**CARSON CITY PURCHASING AND CONTRACTS**  
**201 North Carson Street, Suite 3 Carson City, NV 89701**  
**775-283-7137/FAX 887-2107**  
<http://www.carson.org/index.aspx?page=998>

**NOTICE TO BIDDERS**  
**Advertised Bid #1516-015**  
**East West Transmission Main Ph. 2A-2**

Addendum No. 1

## **BUTTERFLY VALVE COLLAR PLAN**

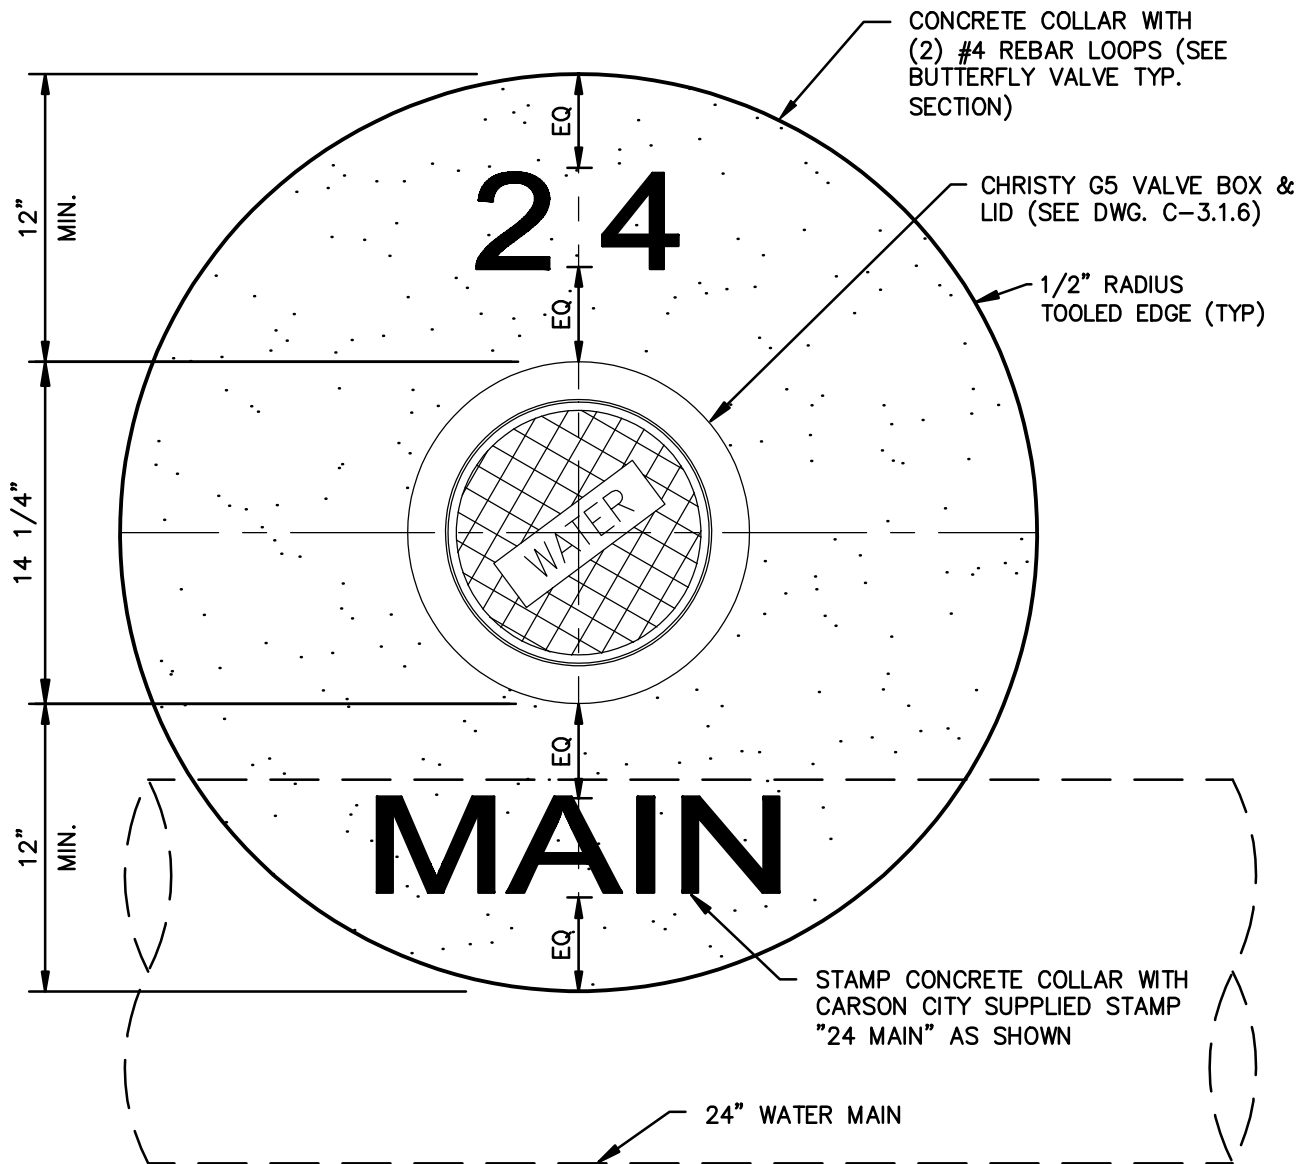
1. As a reminder, this is a federally funded project with Disadvantaged Business Enterprise Requirements. Reference is made to Attachment D regarding goals, procedures that must be followed and forms that must be submitted with bids.
2. Update all asphalt references to include a reference to 75 blow asphalt. All asphalt shall be 75 blow asphalt.
3. Please replace the "Butterfly Valve Collar Plan" detail with the attached detail.

**NOTE:**  
 ORIENT STAMP TO HAVE "MAIN" TEXT  
 ALIGN WITH DIRECTION OF NEW WATER  
 MAIN AND BE ON THE SAME SIDE AS  
 NEW WATER MAIN

REFERENCE STD DWG C-3.1.4 FOR ADDITIONAL NOTES &  
 DETAIL.

1. CONCRETE SHALL CONFORM TO THE SSPWC SECTION 337.10

**SINGLE FITTING RESTRAINED JOINT**  
**165 PSI TEST PRESSURE**

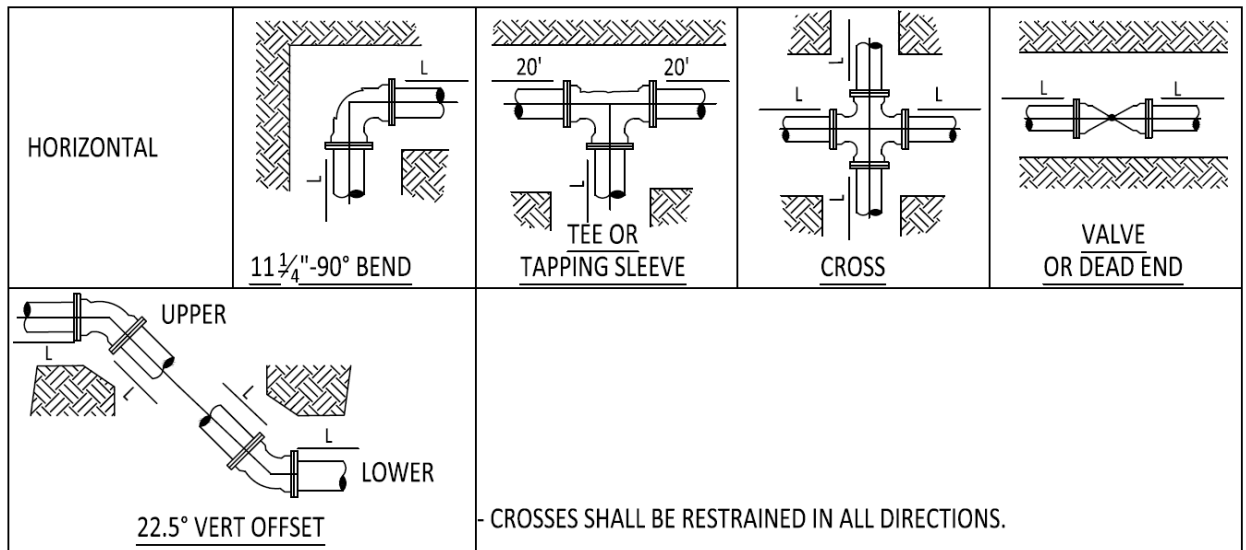
2. Will Carson City perform construction management / administration?  
*Carson City will manage the construction and administer the contract.*
3. Please confirm that restrained lengths will be required on either side of fittings along the 24" water line and that Fusible PVC® pipe is an acceptable alternate for these restrained lengths as specified in previous projects. If this is the case, please provide the required restrained lengths.  
*Restrained lengths are required for all fittings – reference Sheets 7-10, keynote 1 stating "Joint restraints for PVC pipe shall be used on all fittings," and Sheet 1, Note 18 stating "Contractor shall comply with the manufacturers recommendations regarding mechanically restrained joints,*

*and shall ensure that sufficient pipe length is restrained to restrict movement.”*

*Please reference the attached table showing restrained pipe lengths for various joint configurations.*

*If proposing fusible PVC as an alternative to mechanically restrained bell-and-spigot PVC, please provide calculations demonstrating equivalent restraint.*

RESTRAINT LENGTH VALUES WERE CALCULATED IN ACCORDANCE WITH EBAA IRON'S RESTRAINT LENGTH CALCULATOR V7.1.2 (<http://rcp.ebaa.com/calculator.php>), AND THE FOLLOWING INPUTS:

SOIL TYPE: SC  
 SAFETY FACTOR: 1.5 TO 1  
 TRENCH TYPE: 5  
 DEPTH OF BURY: 3.5 FT  
 TEST PRESSURE: 165 PSI

ALL JOINTS WITHIN THE CALCULATED LENGTH MUST BE RESTRAINED.

IF THE DISTANCE BETWEEN FITTINGS IS LESS THAN OR EQUAL TO THE CALCULATED RESTRAINT LENGTH, RESTRAIN ALL JOINTS BETWEEN THOSE FITTINGS.

IF FIELD CONDITIONS DIFFER FROM THE ABOVE, CONTRACTOR SHALL NOTIFY THE CONSTRUCTION MANAGER.
